Comhairle Contae Chorcaí Cork County Council

Subject: WWDL Application For Kanturk REF NO.D0203-01
Response to Notice issued by EPA in accordance with Regulation 18(3)(b) of the Waste Water Discharge
(Authorisation) Regulations 2007 – dated 14th January 2009

REGULATION 18(3)(b) REPLY DATED 11th MARCH 2009

APPLICATION NO. D0203-01

Title:
**Attachment B5
1:500 Location Plan of Stormwater
Overflow SW03-KTRK**

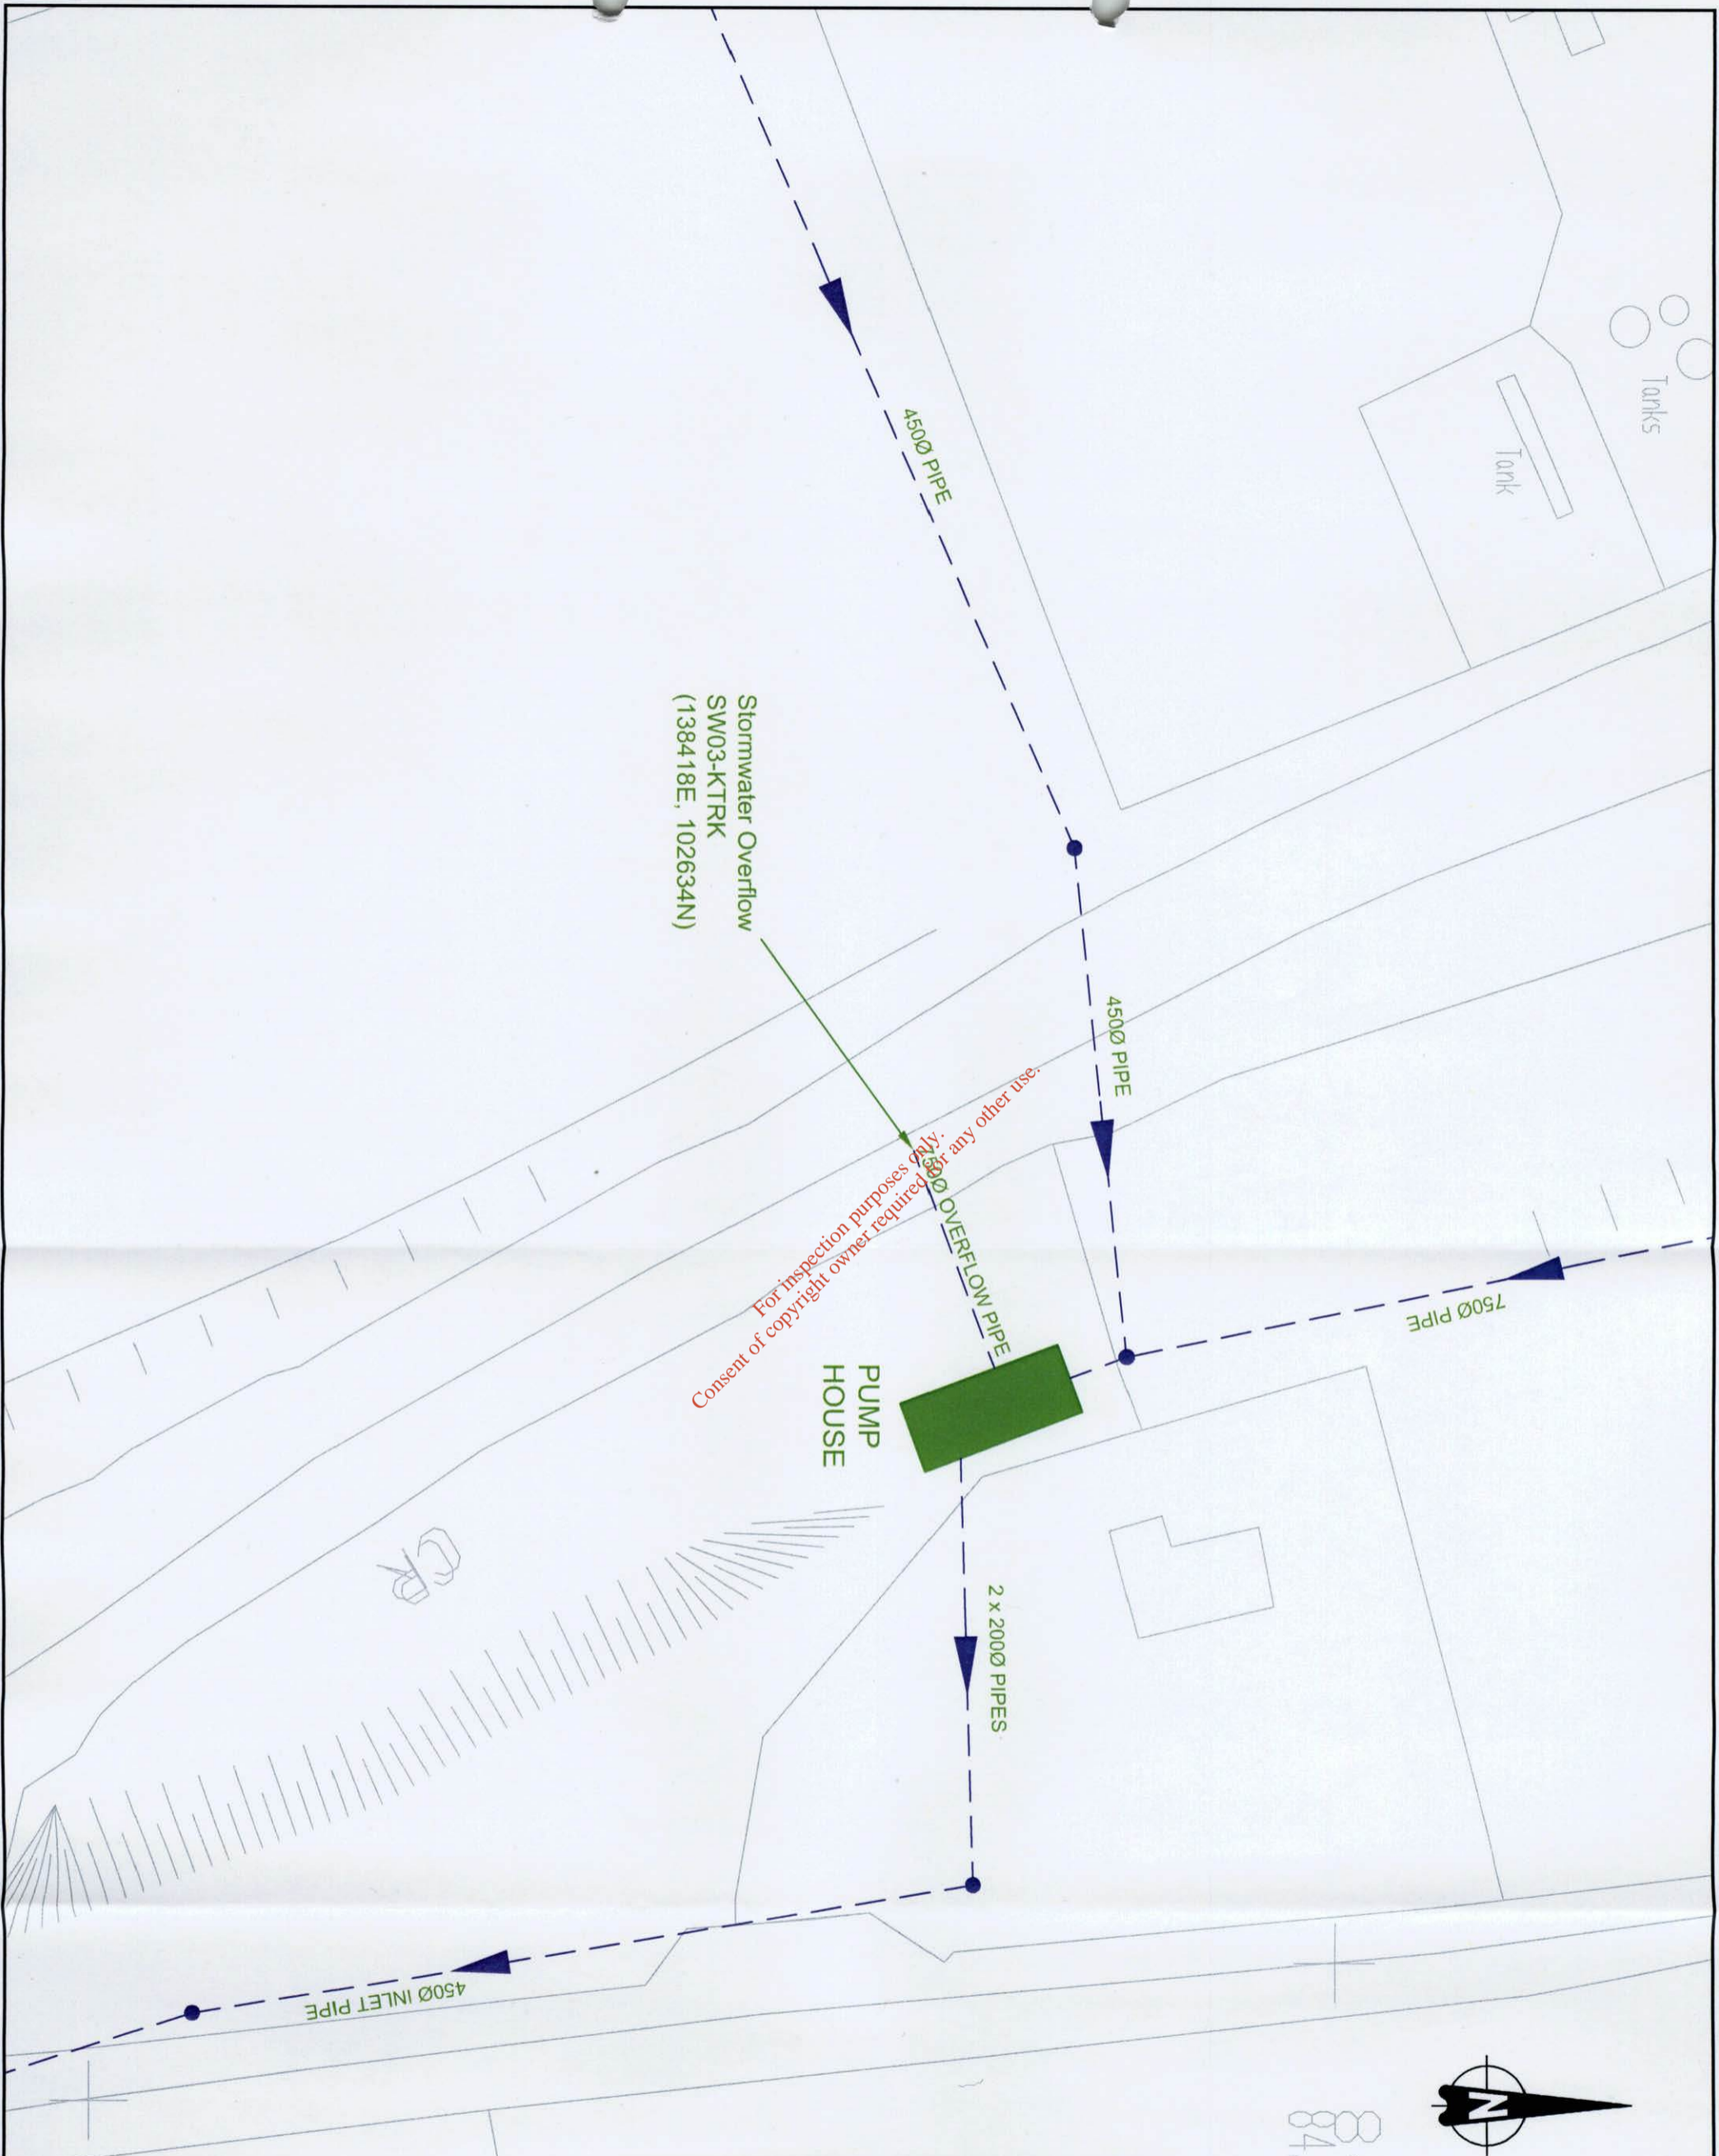
Upon reassessment of the two designated secondary discharges (SW02-KTRK and SW03-KTRK), the emission points have been redesignated as stormwater overflows, with the same designation codes.

As a result of the redesignation the following drawings are withdrawn from Section B.4 and replaced with drawings in Section B.5 according to the table below:

Withdrawn Drawing		Replacement Drawing	
Number	Title	Number	Title
KTRK B4-08	1:500 Location Plan of Secondary Discharge Point, SW02-KTRK	CHVE B5-08	1:500 Location Plan of Stormwater Overflow, SW02-KTRK
KTRK B4-09	1:500 Location Plan of Secondary Discharge Point, SW03-KTRK	CHVE B5-09	1:500 Location Plan of Stormwater Overflow, SW03-KTRK

The locations of the stormwater overflows are shown on Drg. Nos. B5-08 and B5-09 included in Attachment B.5.
